WATER PERMIT NO. 2361-2

Application For Permit To Appropriate Water Within The State Of South Dakota

**SOUTH DAKOTA
WATER PERMIT NO. 2361-2**

REPORT ON
WATER PERMIT APPLICATION NO. 2361-2

SKETCH PLAN OF DAM AND RESERVOIR AREA

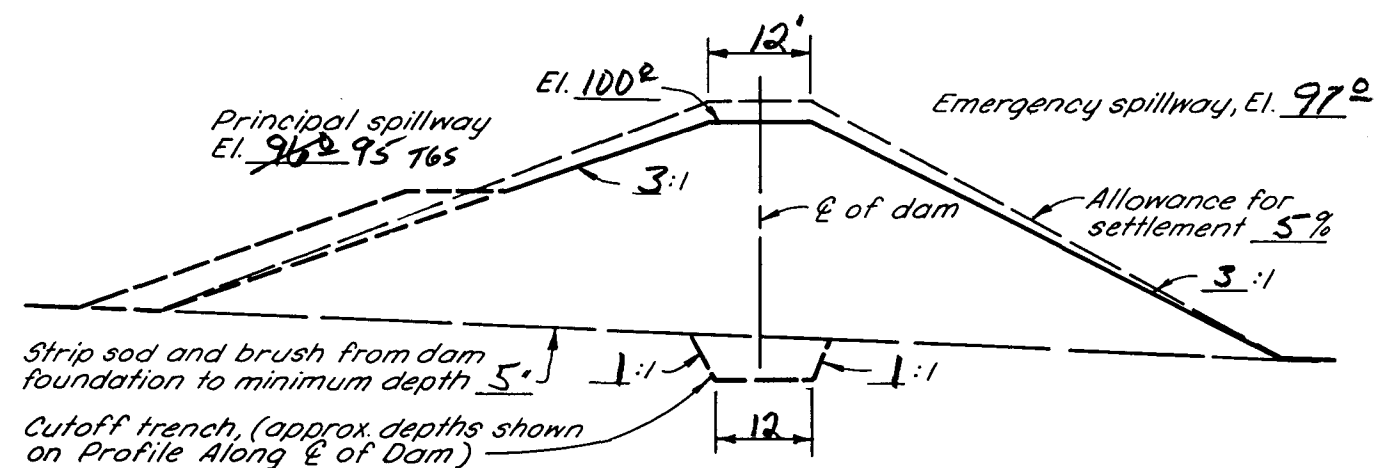
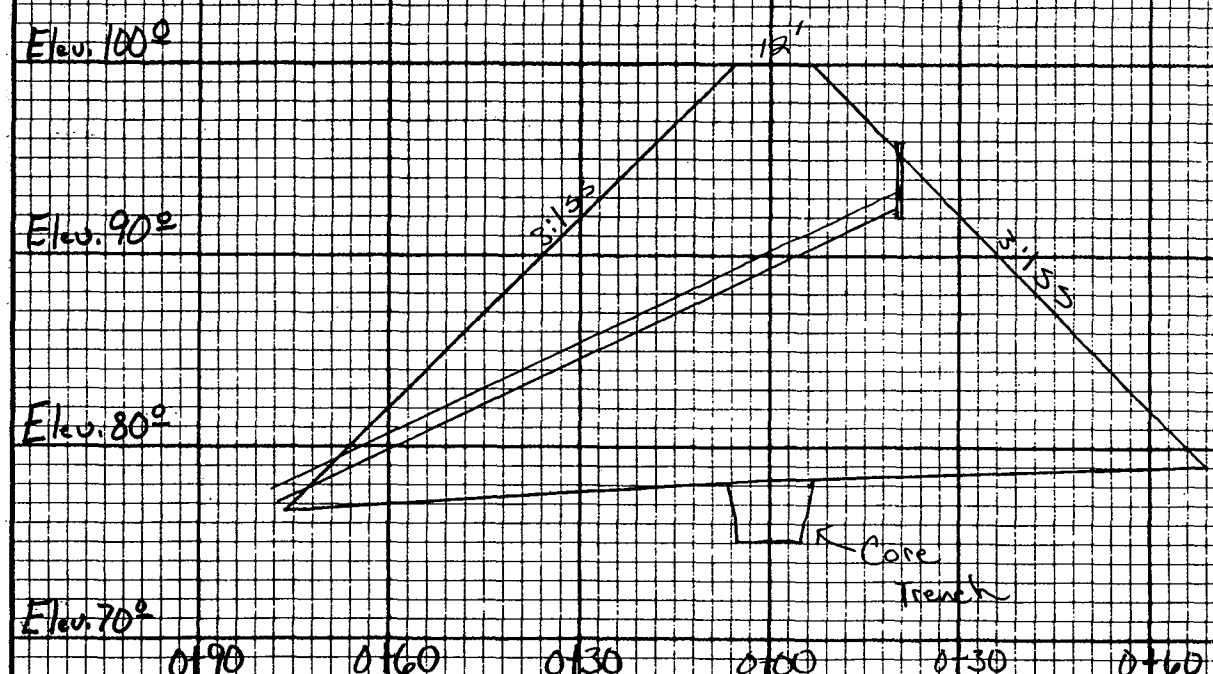
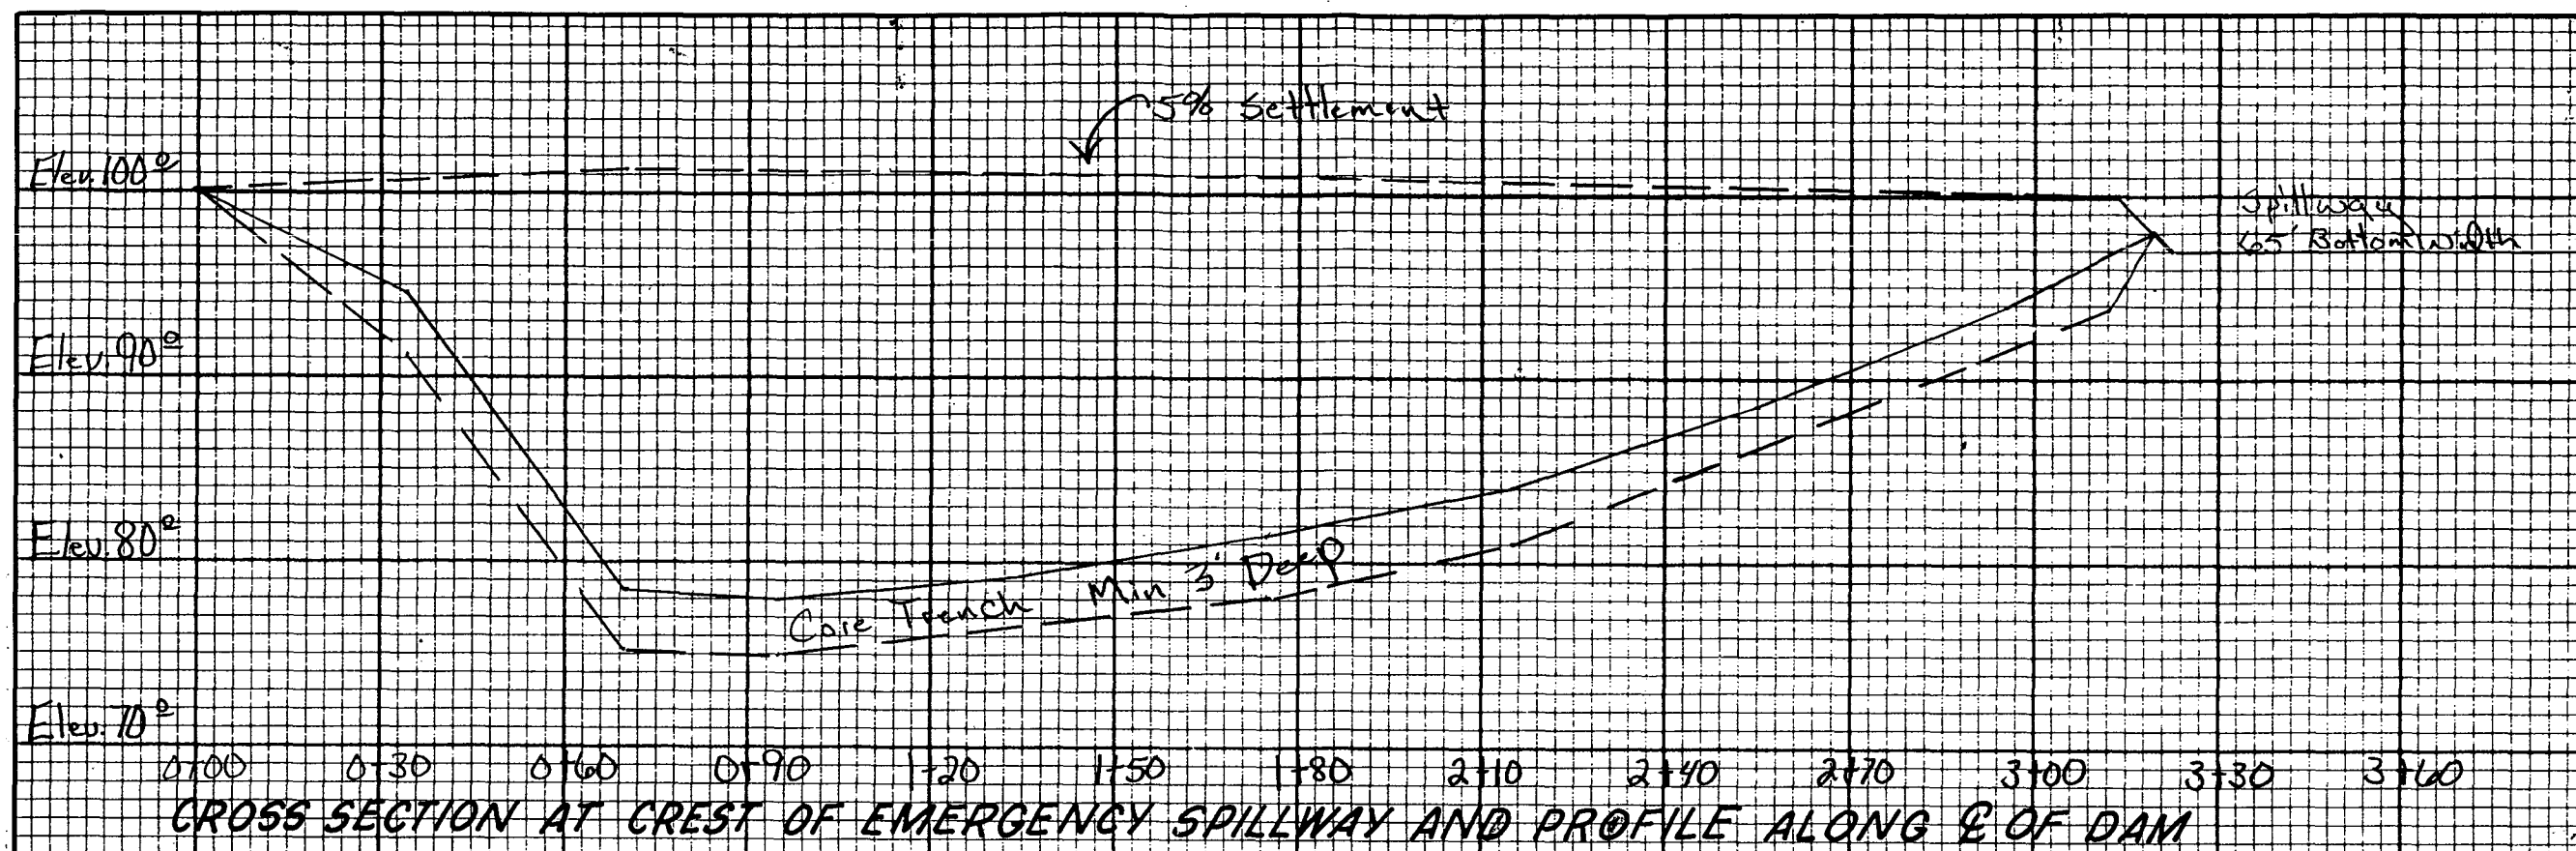
I talked to Kevin Paulsen from the Natural Resources Conservation Service today about the plans for Application No. 2361-2 for Bob and Steve Stoesser. I asked him if the elevation for the primary spillway on the first page of the plans should be 95 instead of 96 as shown, he said yes. I also asked him for the area-capacity data. He said the Normal Capacity was 52.7 acre-feet, the Intermediate Capacity was 67 acre-feet and the Maximum Capacity was 93 acre-feet.

1. Topo Map - OK
2. Dam Axis Profile - OK
3. Dam X-Sec. - OK
4. Area Capacity Data - OK
5. Outlet Details - OK
6. Spillway Routing - 2nd - OK
7. Spillway Details - OK
8. Specs. - std. - OK
9. EPP - N/A Cat. 3 - OK
